STATE OF WASHINGTON DEPARTMENT OF ECOLOGY

Re: Review of March 1, 2017 Draft for Ecology Review Feasibility Study Report

• Site Name: Sound Mattress and Felt Company Site (Site)

Facility/Site No.: 1232087
Cleanup Site ID No.: 1615
VCP Project No.: SW0857

Figure 8

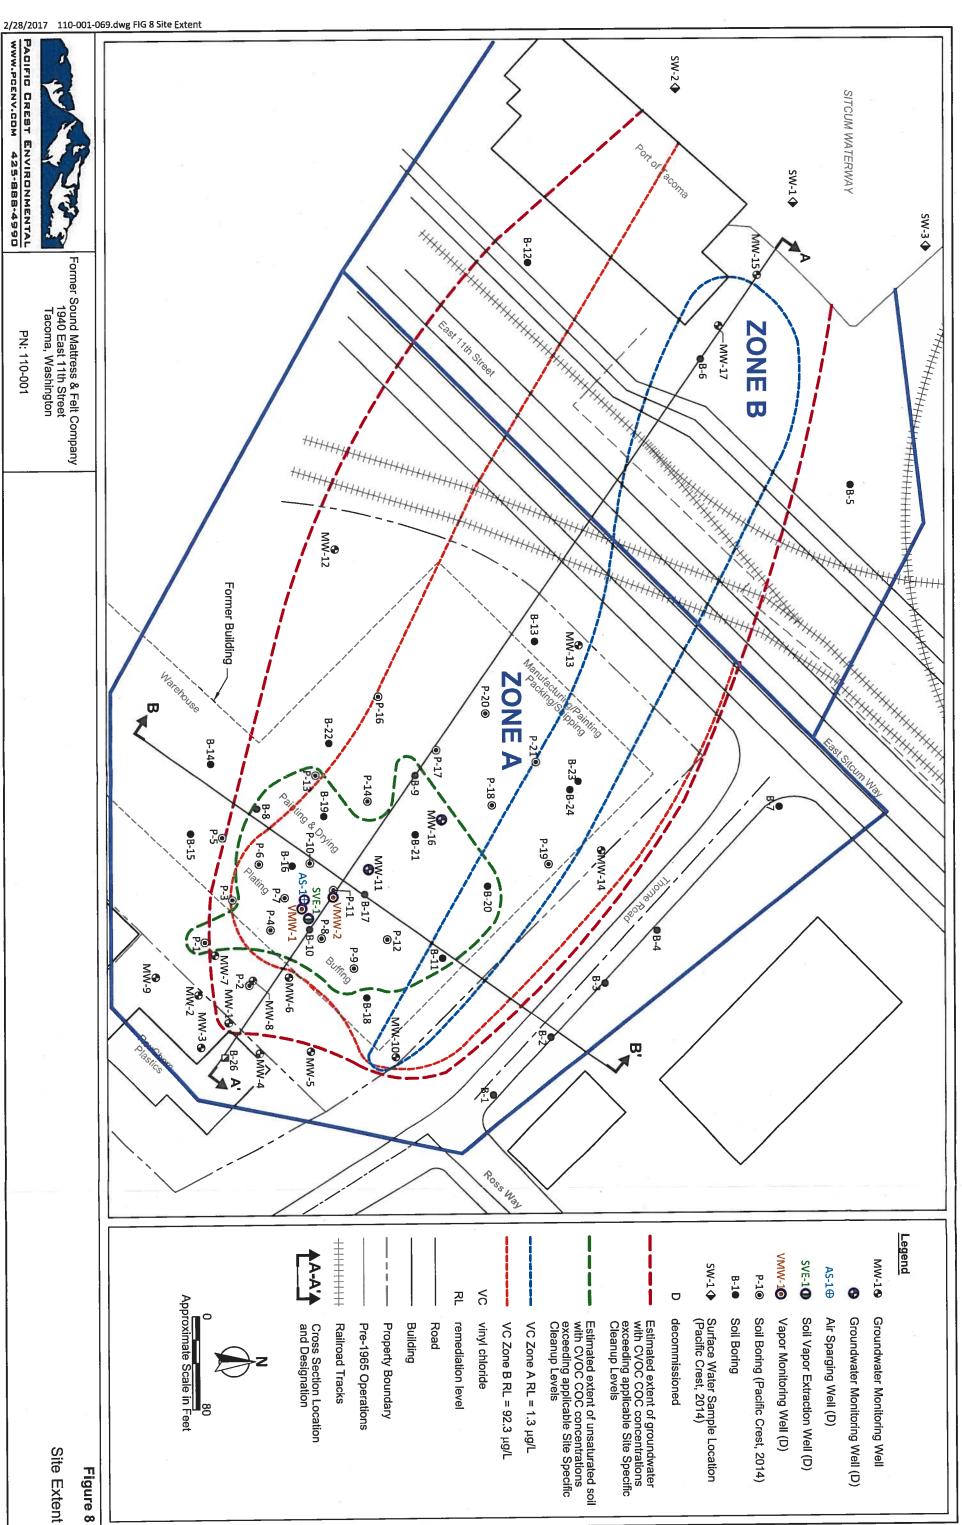
1.1. Review of both the 2017 Draft FS and 2010 Data Gap Report reveal conflicting statements and presentations regarding potential CVOC-impacts to the Sitcum Waterway. For example, Figure 8 in the 2017 Draft FS (attached) depicts the "estimated extent of groundwater with CVOC COC concentrations exceeding applicable Site Specific Cleanup Levels" as extending into the Sitcum Waterway. Conversely, Section 2.3 of the 2017 Draft FS states that unspecified "empirical data" indicates that both PCE and TCE in groundwater do "not currently and is unlikely in the future to ever 'reach' surface water". Additionally, Section 4.2 of the 2010 Data Gap Report included the statement that the "groundwater sample from well MW-15 indicates concentrations of cis-1,2-DCE and VC in groundwater are likely impacting surface water in the Sitcum Waterway" (Ecology's emphasis). As indicated above, no specificity was provided regarding the "empirical data" referenced as supporting the conclusion that CVOCs have not impacted the Sitcum Waterway. Ecology concurs with the assessment provided in the 2010 Data Gap Report indicating that CVOCs have likely reached surface water within the Sitcum Waterway.

While Ecology acknowledges that deployment of passive diffusion bag (PDB) samplers during October of 2014 did not detect concentrations of CVOCs above their respective reporting limits in surface water within the Sitcum Waterway, an evaluation of sediment at the associated groundwater/surface-water interface has not been performed, thus representing a significant data gap in terms of Site characterization.

To resolve the uncertainties regarding whether CVOCs have reached the Sitcum Waterway and whether these constituents are present within the groundwater-surface water interface, please provide a proposal to further evaluate sediment within the Sitcum Waterway. Ecology acknowledges that the presence of rip-rap along the submerged margins of the Sitcum Waterway present challenging physical conditions, however, further evaluation of submerged media beneath this area of the Site is warranted. Ecology recommends evaluating the use of push-probe or angled-boring techniques to access sediment immediately beneath the rip-rap. The presence of seeps beneath the rip rap cover during low tidal stages should also be evaluated in this area of the Site. If observed, it is further recommended that seep samples be collected for CVOC analysis.
